# Access Compliance Report

## Public Rights-of-Way

### (Pedestrian Signals)

Intersection ID: N/A	Main Street:	Cross Street: N/A	Location: N/A
ADA ID: D416C5025928	Signal Type: One Push Button-APS	Overall Compliance: No	Severity Score: BTN 1: N/A BTN 2: N/A No BTN: N/A
Codes/Mitigation Info/Possible Solution		Field Measurements/Component Compliance

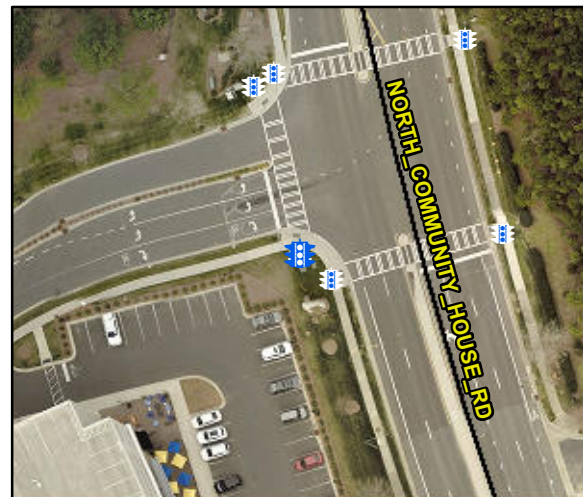
Possible Solutions: Replace Signal Push Button With APS Button on New Post. Remove & Relocate Sign.

PROW/ADA: TMUTCD 4e.08, R404.2, R209.1, MUTCD 4e.10

Yes	B 1 Clear Xing Direction?	ClearlyMarked	N/A	B 2 Clear Xing Direction?	N/A
	B 1 Crossing Direction	To NW		B 2 Crossing Direction	N/A
Yes	B 1 DistanceTo XWalk (in)	17.0	N/A	B 2 DistanceTo XWalk (in)	N/A
No	B 1 DistanceTo Curb (in)	110.0	N/A	B 2 DistanceTo Curb (in)	N/A
Yes	B 1 Diameter (in)	2.0	N/A	B 2 Diameter (in)	N/A
